SUBJECT: LETTER OF CLARIFICATION AND BID ADDENDUM NO. 1

INFRASTRUCTURE AT LITTLE CHOCOLATE BAYOU COUNTY PARK FOR CALHOUN COUNTY, TEXAS – TEXAS GENERAL LAND OFFICE CONTRACT NO. 20-065-064-C182 AND CALHOUN COUNTY 2020 CDBG-DR CONTRACT WORK ORDER NO. E-1

A D D E N D U M N O . 1

INFRASTRUCTURE AT LITTLE CHOCOLATE BAYOU COUNTY PARK PLAYGROUND IMPROVEMENTS

PROJECT NO. 5310.011E
SCALE:	AS NTD.
DWN. BY:	SPM
CHK. BY:	SPM
DATE:	03/22/21
SHT. NO.	C1.0

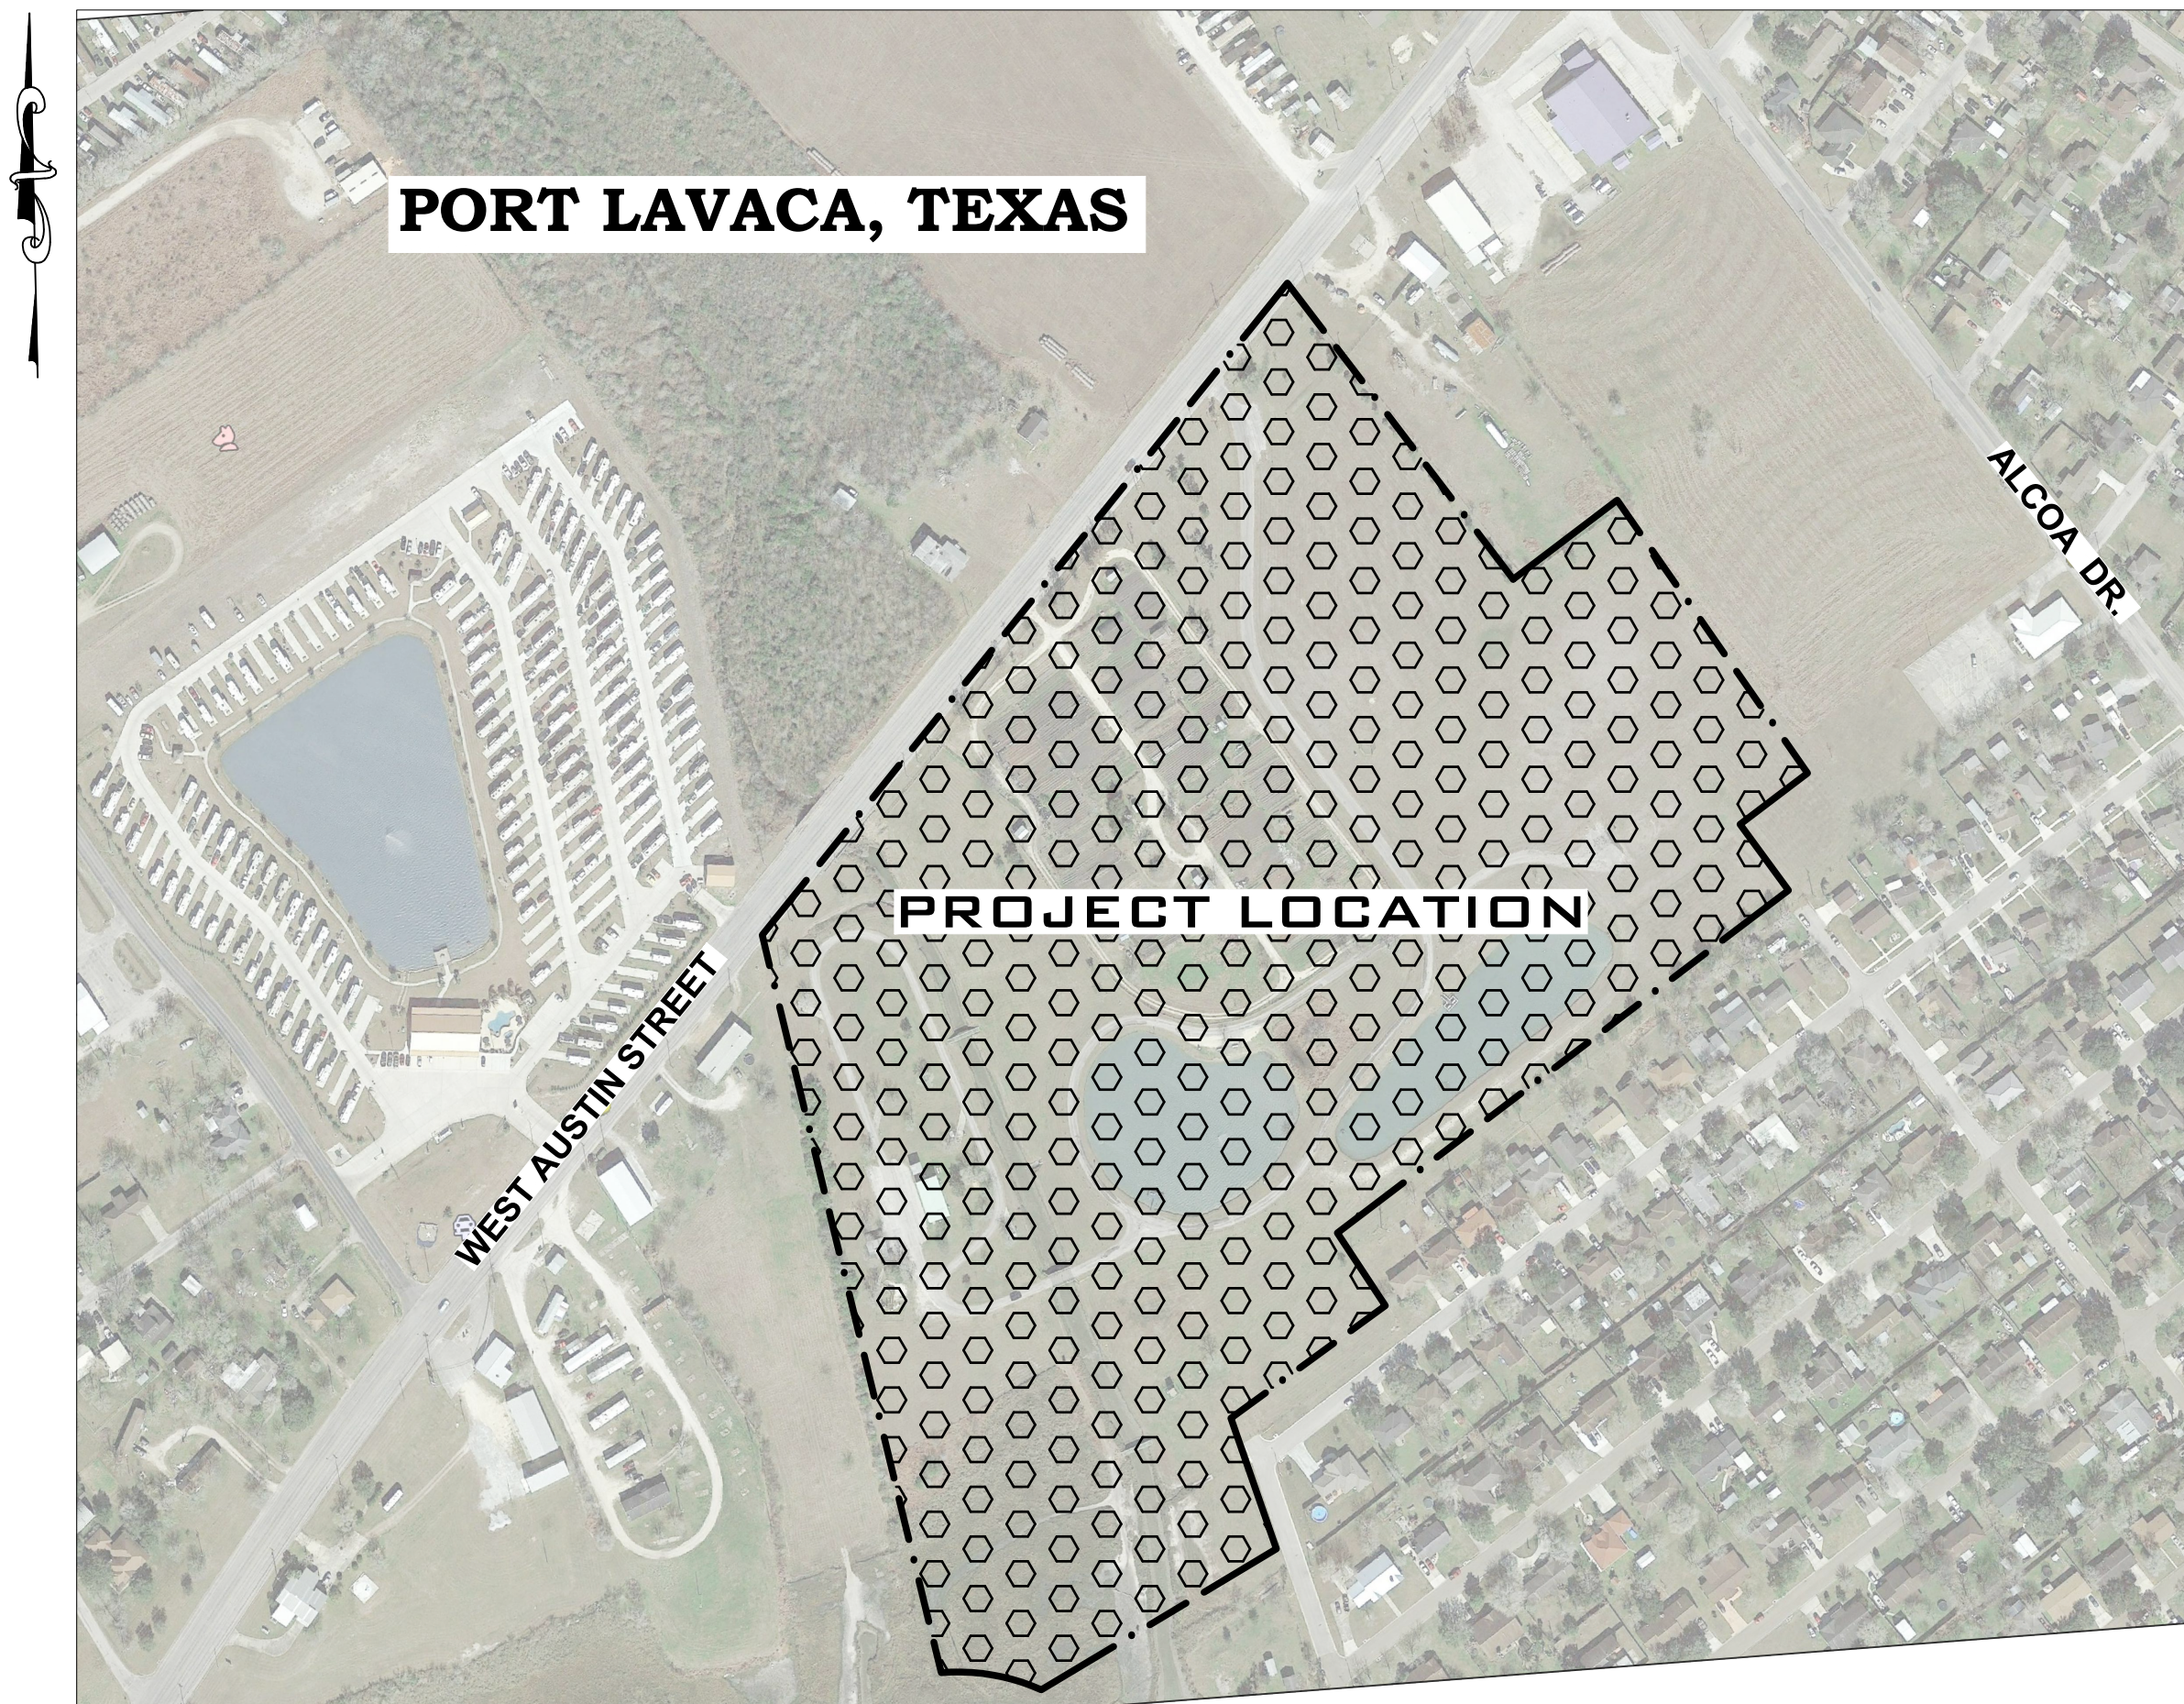
- REMOVE:** Sheet C3.2
This sheet has been removed entirely.
- REMOVE:** Sheets C1 & C3.1
REPLACE with: “Revised” Sheets C1 & C3.1 with Rev B, signed for 06/08/2021.
